# Site Accessibility Evaluation

### **Black Forest Regional Park**

**Accessibility Evaluation**

***Inspection Date: 08/09/2017  
Inspector: David Mejia***

### **Finding: 3**

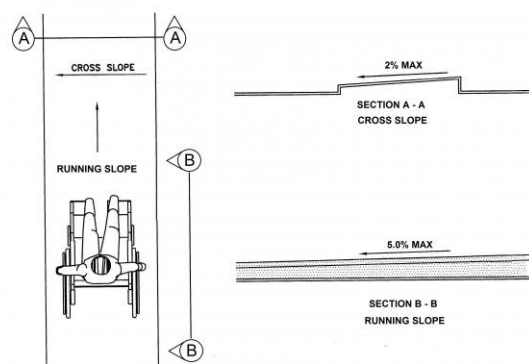
The accessible route contains running slopes greater than 5 percent and cross slopes greater than 2 percent across the width of the walk and has not been constructed as a ramp (i.e. handrails, wheel guides, etc.).

**Running slope ranged  
from 6.6% to 7.3% //  
Cross slope ranged  
from 2.1% 3.0%**

**Install handrails on both sides that comply with 505 due to the running slope exceeding the maximum slope allowed (1:20 or 5.0%).**

**Add level landings at the top and bottom of the ramp run and every 30 feet in between complying with 405.6**

### **Finding: 4**

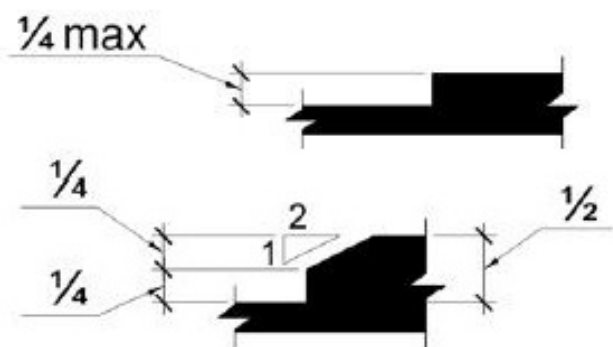
The walkway contains abrupt vertical edges and/or variations over 1/4 inch.

3/4 inch upheaval

Corrective action: Work order #463245 submitted on 5/20/19

### **Finding: 6**

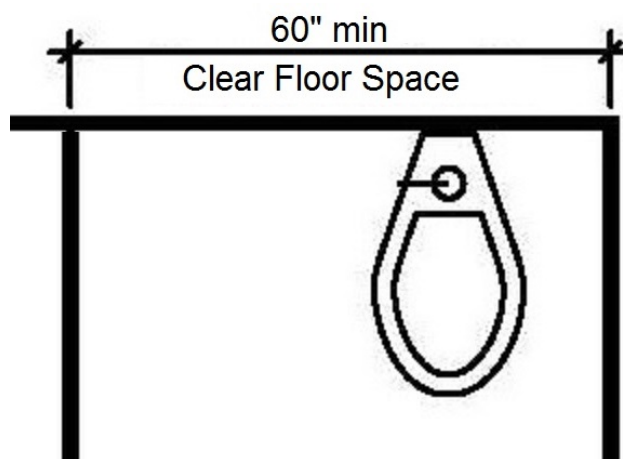
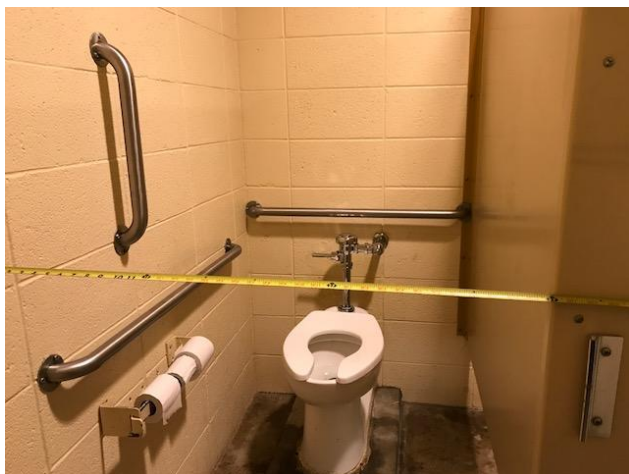
**The toilet compartment is not wide enough.**

**Toilet closet measured  
36 inches wide.**

**Major remodel/construction will be required to meet current ADA Standards.**

### **Finding: 7**

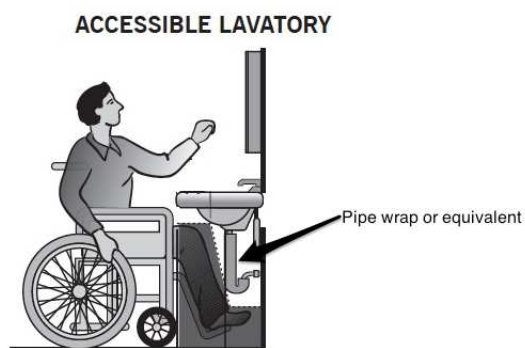
The water and drain pipes under the lavatory are not adequately insulated.

Drain pipes not insulated

Insulate drain pipes underneath lavatory.

Corrective action: Work order #463246 submitted on 5/20/19

Corrected on 6/5/19.

### **Finding: 8**

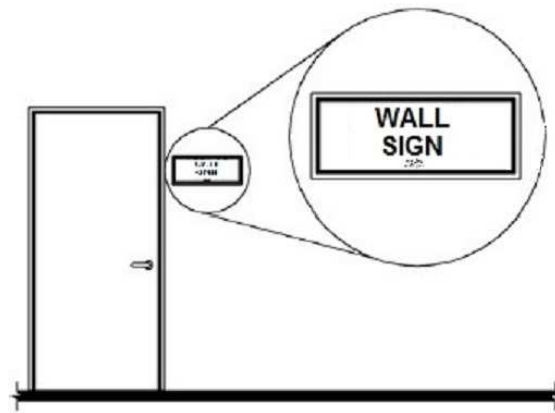
**The tactile sign is incorrectly located.**

**Tactile sign mounted directly on door.**

**Move sign to left/latch side of door 48 inches minimum above finish floor or ground surface measured from the lowest tactile character or 60 inches maximum from the highest tactile character.**

**Corrective action: Work order #463251 submitted on 5/20/19**

### **Finding: 9**

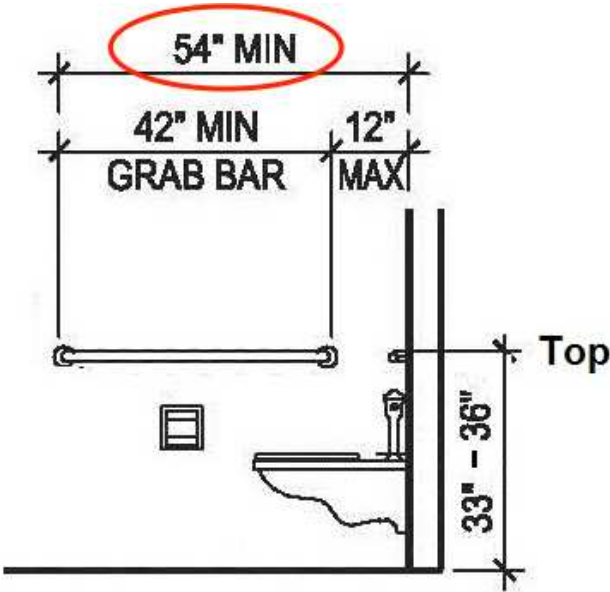
The side grab bar does not extend far enough from the rear wall.

Side grab bar does not extend the 54 inches required per ADA.

Re-position side grab bar an additional 1.75 inches away from rear wall to meet the 54 inch minimum required per ADAS.

Corrective action: Work order #463253 submitted on 5/20/19

### **Finding: 10**

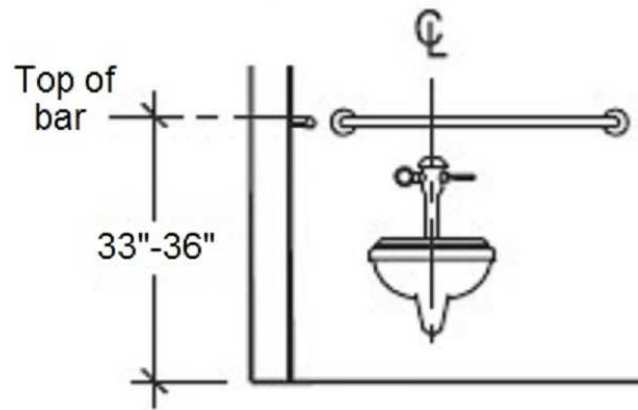
The rear grab bar is too high.

Measures 37 inches to the top of the gripping surface.

Remove and re-position 1 inch lower to comply with ADAS.

### **Finding: 11**

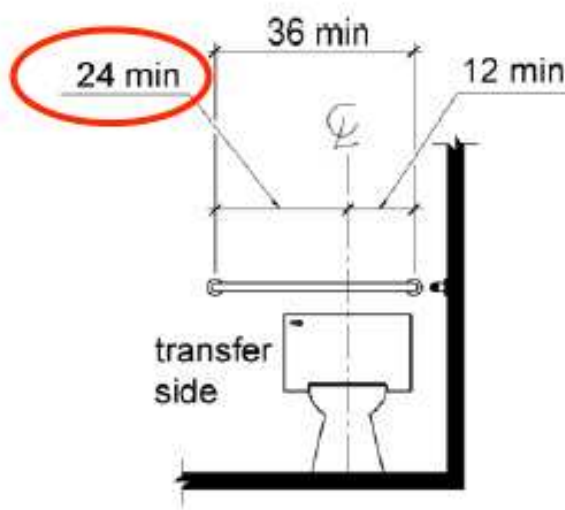
The rear grab bar does not extend adequately past the toilet on the wide side.

Width of toilet  
compartment does not  
allow for compliance

Extend width of toilet compartment and re-position rear grab bar to meet ADAS.

### **Finding: 12**

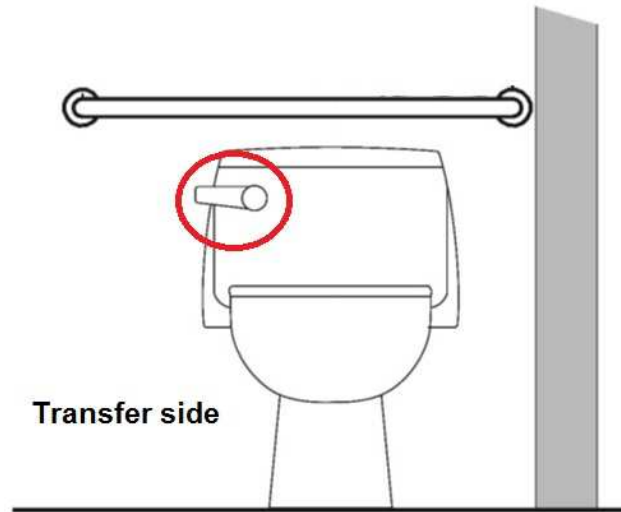
The flush handle is located on the wrong side of the toilet.

Flush handle not on transfer side of water closet

Extend width of toilet compartment and ensure flush handle is on the open side of the water close.

Corrective action: Work order #463256 submitted on 5/20/19  
Corrected on 6/5/19.

### **Finding: 13**

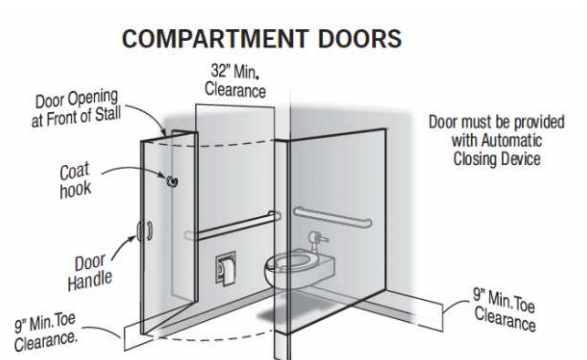
**The compartment door does not have an unobstructed clear opening width of 32 inches.**

**Door opening width is  
29 1/2 inches.**

**Upon reconstruction and/or alteration extend water closet door width to 32 inches minimum per 2010 ADAS.**

### **Finding: 14**

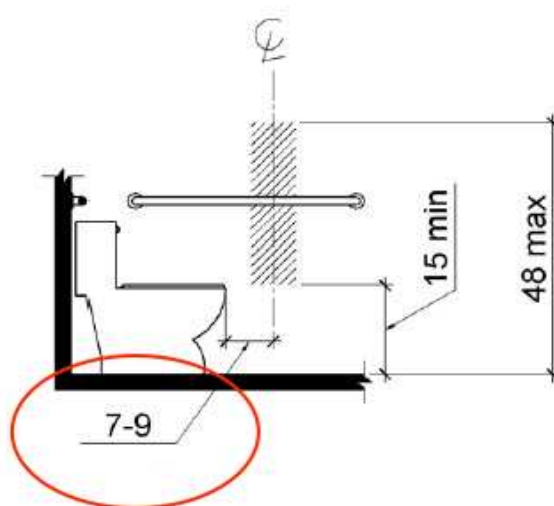
The toilet paper dispenser does not allow a continuous flow.

Does not allow  
continuous flow of  
toilet paper.

Replace dispenser with one that will allow continuous flow.

Corrective action: Work order #463258 submitted on 5/20/19

### **Finding: 15**

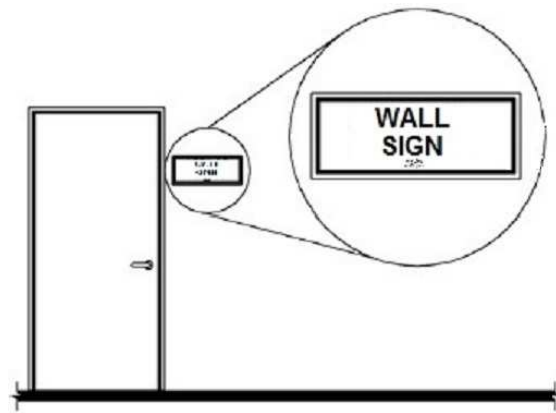
**The tactile sign is incorrectly located.**

**Tactile sign mounted  
directly on door.**

**Move sign to left/latch side of door 48 inches minimum above finish floor or ground surface measured from the lowest tactile character or 60 inches maximum from the highest tactile character.**

**Corrective action: Work order #463252 submitted on 5/20/19**

### **Finding: 16**

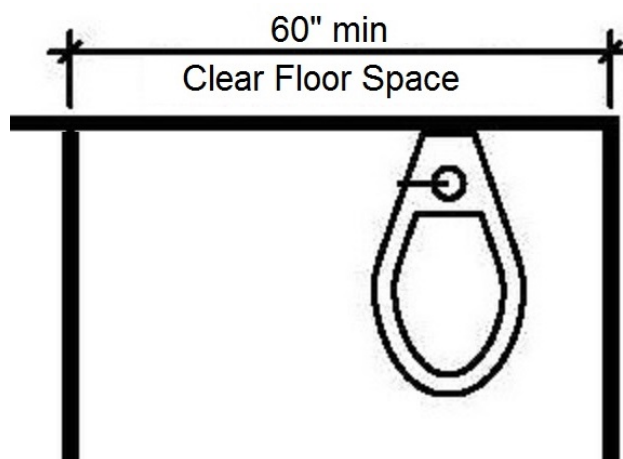
**The toilet compartment is not wide enough.**

**Toilet closet measured  
37 inches wide.**

**Major remodel/construction will be required to meet current ADA Standards.**

### **Finding: 17**

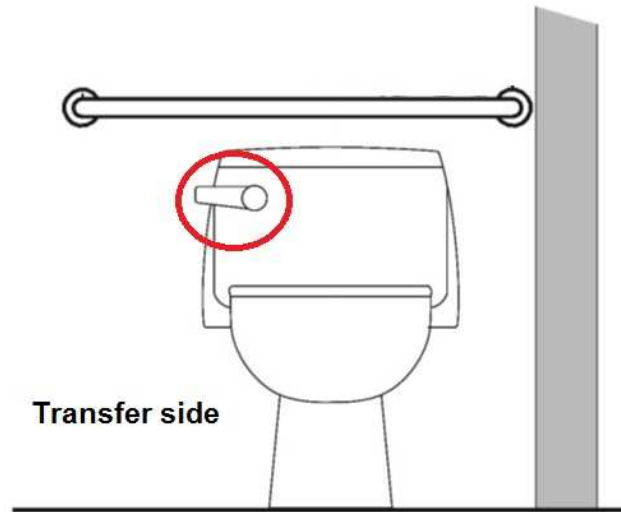
The flush handle is located on the wrong side of the toilet.

Flush handle not on transfer side of water closet.

Extend width of toilet compartment and ensure flush handle is on the open side of the water close.

Corrective action: Work order #463255 submitted on 5/20/19  
Corrected on 6/5/19

### **Finding: 18**

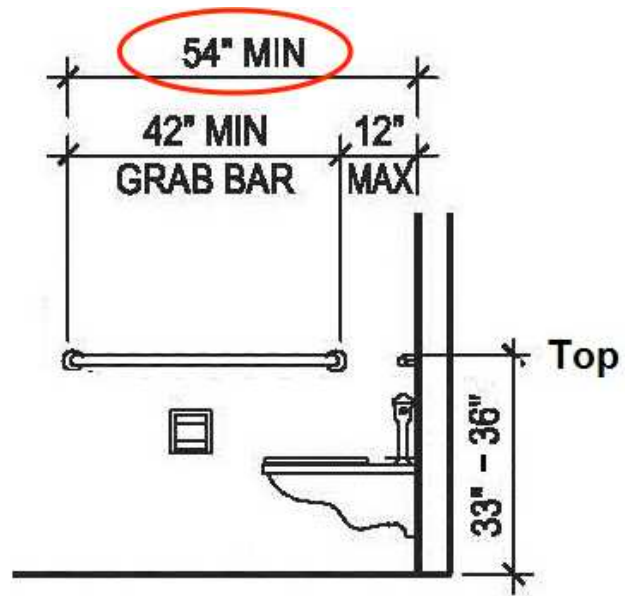
The side grab bar does not extend far enough from the rear wall.

Side grab bar does not extend the 54 inches required per ADA.

Re-position side grab bar an additional 1.75 inches away from rear wall to meet the 54 inch minimum required per ADAS.

Corrective action: Work order #463254 submitted on 5/20/19

### **Finding: 20**

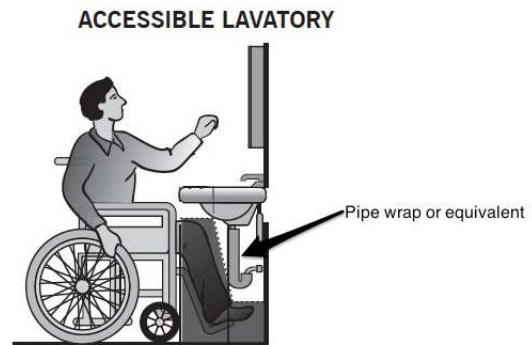
The water and drain pipes under the lavatory are not adequately insulated.

Drain pipes not insulated

Insulate drain pipes underneath lavatory.

Corrective action: Work order #463248 submitted on 5/20/19

Corrected on 6/5/19.

### **Finding: 21**

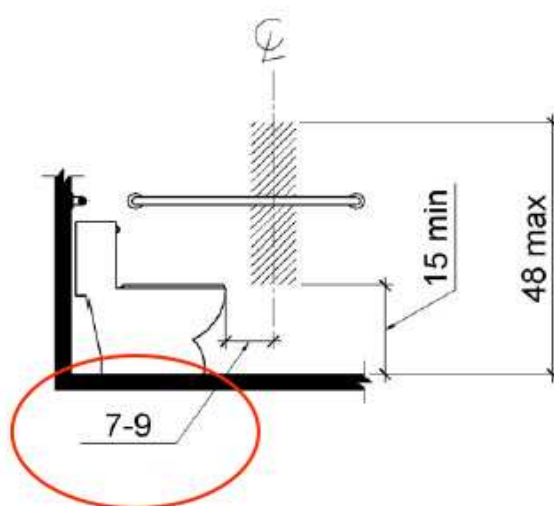
The toilet paper dispenser does not allow a continuous flow.

Does not allow  
continuous flow of  
toilet paper

Replace dispenser with one that will allow continuous flow.

Corrective action: Work order #463258 submitted on 5/20/19

### **Finding: 22**

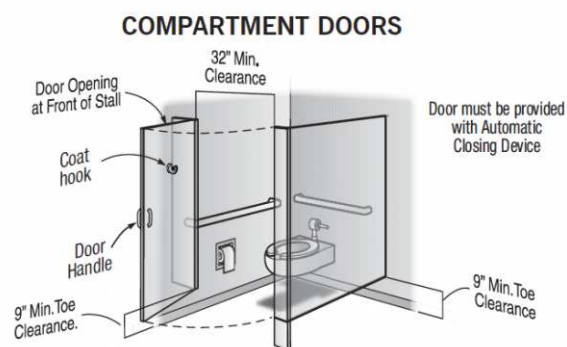
**The compartment door is not self closing.**

**Compartment door not  
self closing**

**Adjust or install automatic closing hinges.**
